Brandix Apparel Bangladesh Ltd. (Extension)

Structural Inspection Report

FG warehouse & Finishing Building 3-storied (G+2) RC building.

Possible vehicle impact on ground floor columns

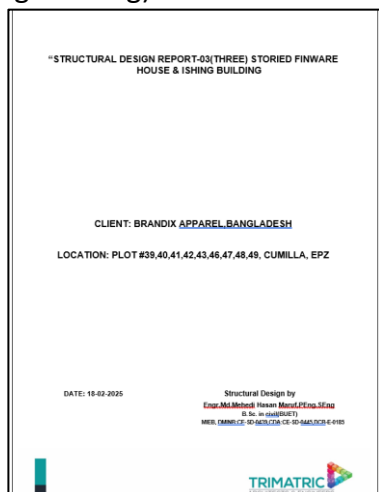
Observation 2: Possible vehicle impact on ground floor columns (FG Warehouse & Finishing Building).

Description: Ground floor columns were found susceptible to vehicle impact. The building engineer is required to provide barrier around the columns to protect from vehicle impact.

SL	Observation	Action Plan	Timeline
1.	Design report needs to be reviewed against lateral forces (Main Factory Building).	The building engineer is required to submit the prepared design report to RSC for review against lateral forces.	within 6 weeks
2.		Carry out remedial work and implement loan management plan.	within 6 months
3.	Possible vehicle impact on ground floor columns (FG Warehouse & Finishing Building).	The building engineer is required to provide separate barrier around the columns to protect from vehicle impact.	within 6 months
